Access Compliance Report

Public Rights-of-Way

(Curb Ramps)

Intersection ID: N/A	Main Street: ARBOR_LOOP_DR	Cross Street: ANSLEY_GARDEN_DR	Location: N
ADA ID: 8B842748A869	Ramp Type: Perp	Initial Pass/Fail: Fail	Overall Compliance: No
Severity Score: 12.5			
Codes/Mitigation Info/Possible Solution		Field Measurements/Component Compliance

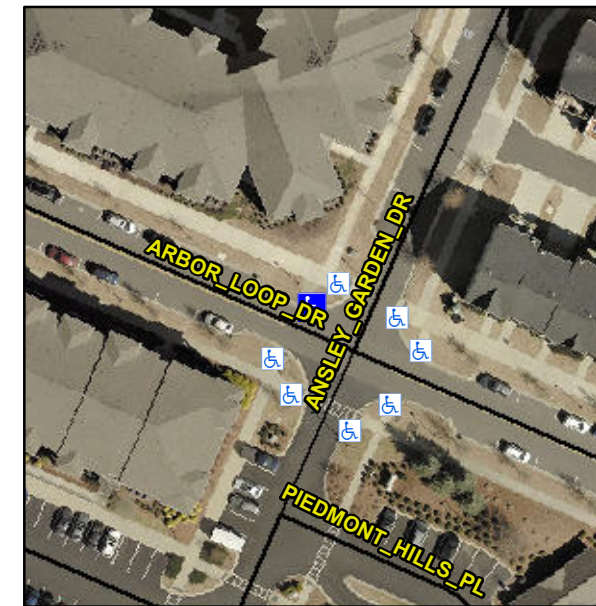
R304.2.2

Compliance	Description	Data	Compliance	Description	Data
N/A	Ramp Length (in)	76.0	No	Ramp Slope (%)	8.9
Yes	Ramp Width (in)	69.5	Yes	Ramp XSlope (%)	0.2
N/A	Flare Type LT	N/A	N/A	Flare Type RT	N/A
N/A	Flare Slope LT (%)	N/A	N/A	Flare Slope RT (%)	N/A
N/A	Flare Traversable LT?	No	N/A	Flare Traversable RT?	No
N/A	Landing Length (in)	N/A	N/A	DWS Provided?	N/A
N/A	Landing Width (in)	N/A	N/A	DWS Contrast?	N/A
N/A	Landing Slope (%)	N/A	N/A	DWS Length (in)	N/A
N/A	Landing X Slope (%)	N/A	N/A	DWS Full Width?	N/A
N/A	Landing Curb? (Y/N)	N/A	N/A	DWS Offset (in)	N/A
N/A	Shared Landing?	N/A			
N/A	Gutter Ponding?	N/A	N/A	Gutter Slope (%)	N/A
N/A	Gutter Lip Ht (in)	N/A	N/A	Gutter X Slope (%)	N/A
N/A	Painted X Walk1?	No	N/A	Painted X Walk2?	N/A
	X Walk 1 Direction	To SW		X Walk 2 Direction	N/A
N/A	X Walk 1 Width (in)	N/A	N/A	X Walk 2 Width (in)	N/A
	X Walk 1 Slope (%)	0.7		X Walk 2 Slope (%)	N/A
	X Walk 1 X Slope (%)	0.9		X Walk 2 X Slope (%)	N/A

Remove & Replace Entire Ramp.
